New firmware release 00_08_12.1

For the HP Stitch Sx00 printer series

February 2024

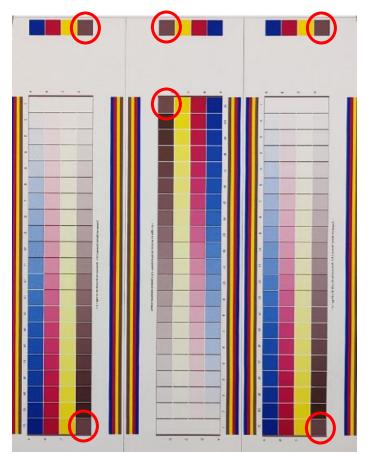
- Security fixes: fixed EWS vulnerability threat.
- New Gen5 certificate bundles added to HP Stitch Sx00 series: as current certificates will no longer be valid at certain time with this FW version. The digital certificates have been updated using Gen5.
- Fixed CLC problem in Sx00 series: due to a firmware bug, the 100% black ink patch could have lower ink density than previous patches after conducting a color calibration procedure.
